# Release Notes

TRIMBLE FIELD SYSTEMS

September 2025 (Updated October 2025)

### Trimble GNSS firmware version 6.43 (September 2025)

### Install new firmware via WebUI

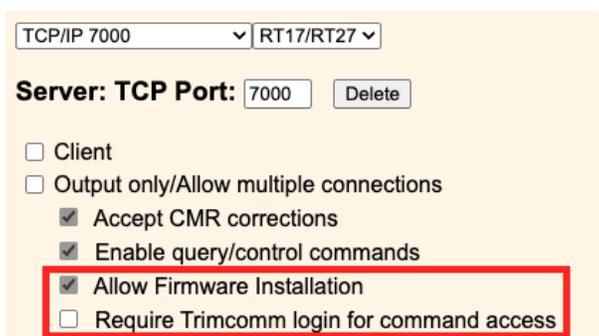
For receivers activated for the first time after the release of Trimble GNSS firmware version 6.43, firmware installation via the WebUI is disabled by default. Users may manually enable firmware installation by selecting “Allow New Firmware To Be Installed” (*Firmware / Install*).

## New Trimble RTX Fast Coverage for the Republic of Korea (South Korea)

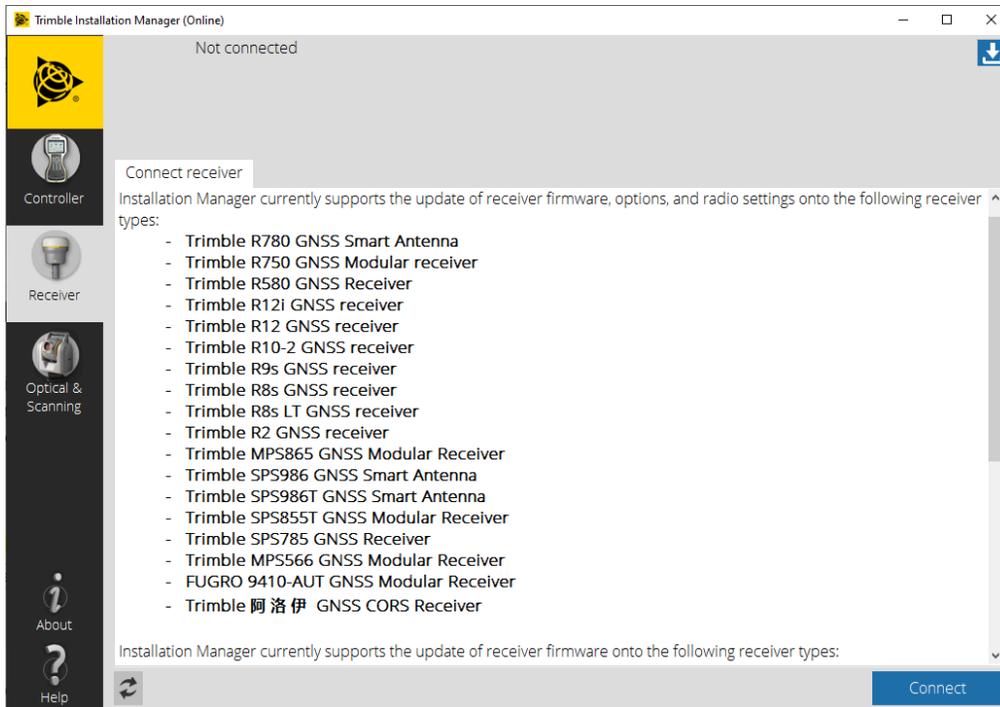
Trimble has announced a new regional area network providing CenterPoint® RTX Fast services for the Republic of Korea. In this area, regional atmospheric models to mitigate ionospheric and tropospheric biases are available from a dense network of Trimble RTX® reference stations via the internet on the RTXKR mount point. L-band users will continue to utilize the RTX Pacific-Asia (RTXPA) beam with global ionospheric models.
